AMENDMENT OF SOLICITATION/MODIFICATION OF CONTRACT			1. Contract Number DCAM-2008-B-0048	Page of Pages 1 19	
2. Amendment/Modification Number 3		3. Effective Date 15-Apr-08	4. Requisition/Purchase Request No.	5. Solicitation Caption Build-Out of OAG @ OJS

Partial Build-out Office of Attorney General

RESPONSE TO OFFERORS QUESTIONS

Bulletin #2

TYP. OFFICE DOOR/WINDOW

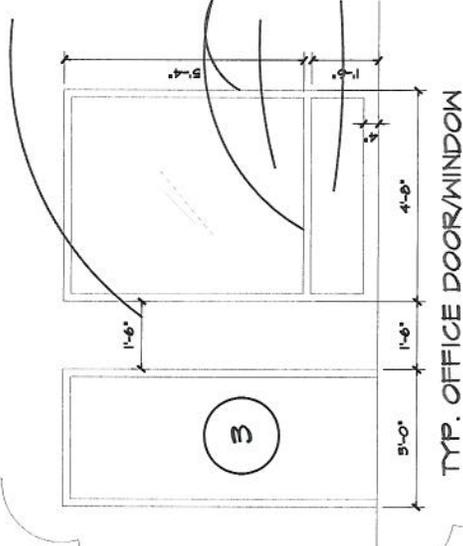
IFB Section	Page #	Question	Response
22			Specification Section 08800 – Glazing refers to Section 08849 – Aluminum Entrance and Window Wall. This section is not included.	
23			Please specify glazing for windows.	¼” Reeded Glass and ¼” heat strengthen Reeded Glass where applicable
24			Please confirm the Corridor Carpet Type.	Please see revised sheet A-3.
25			Door Schedule shows Door No. 1100, 1105 and 1110 as “New Door”. Are existing doors and frames to be reused for the remaining doors on the Door Schedule. Is the Aluminum Storefront 1245 the salvaged storefront identified for reuse in C5.1.	No, existing doors and frame are to be salvaged. All proposed doors and frames are new. Please see revised door schedule on sheet A-3.
26			Are Door Stops, Closers required for doors. If required, specify types.	Door stops and closers are shown on revised sheet A-3.
27			Is the wood veneer/plywood to be Mahogany, or does the stain color to be Mahogany Dark? If only the stain color is to be Mahogany Dark, please specify wood veneer for the face of the plywood core.	Mahogany veneer with dark stain.

NOTE:
IF WINDOW IS MORE THAN
2'-0" FROM AN
ADJACENT DOOR, THEN
1/4" HEAT STRENGTHENED
REEDED GLASS

A-6

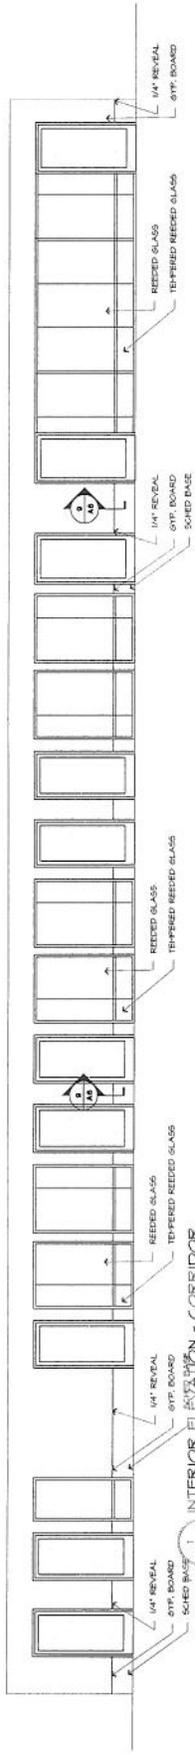
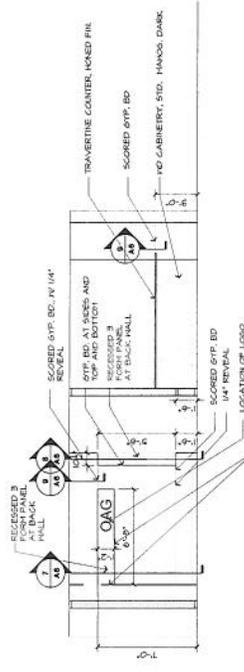
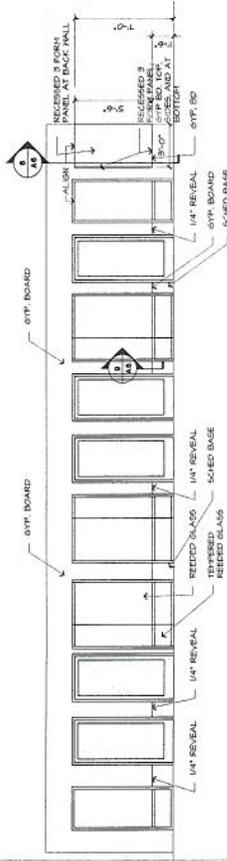
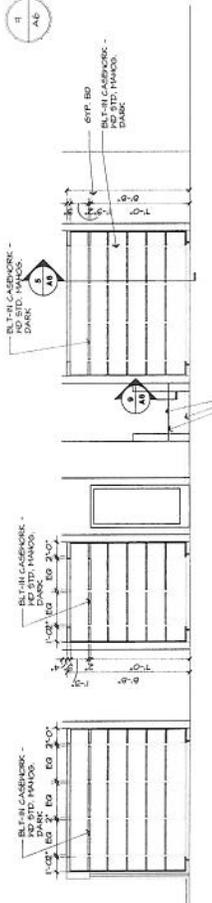
IFB Section	Page #	Question	Response
36			Drawing D1 indicates 4,388 sq ft of demo, however our takeoff (scale) indicates roughly 5,300 sq ft., please advise what is correct?	Disregard the 4388 sq ft number. The square foot is approx. 6000 sf
37			Drawing A-3 indicates 1100 & 1105 (head & jamb details), however 6 & 8 on drawing A-5 details do not exist?	Please see revised sheet A-3 for door and jamb detail locations.
38			Drawing A-3 Doors 1100, 1105, 1110, 1250, 1260, 1270 & 1280 do not indicate any details are these existing doors please clarify?	Please see revised sheet A-3 for door and jamb detail locations.
39			Room finish schedule room 1140 & 1145, floor schedule does not correspond with floor plan?	Please see revised sheet A-3 for room finish and floor finish modifications.
40			Drawing A-5, please clarify frame type for typical window (HM or Alum.)?	Hollow Metal (HM0.
41			Drawing A-6 indicates elevations 1,2,3 & 4 are not indentified on floor plan?	See revised sheet A-1
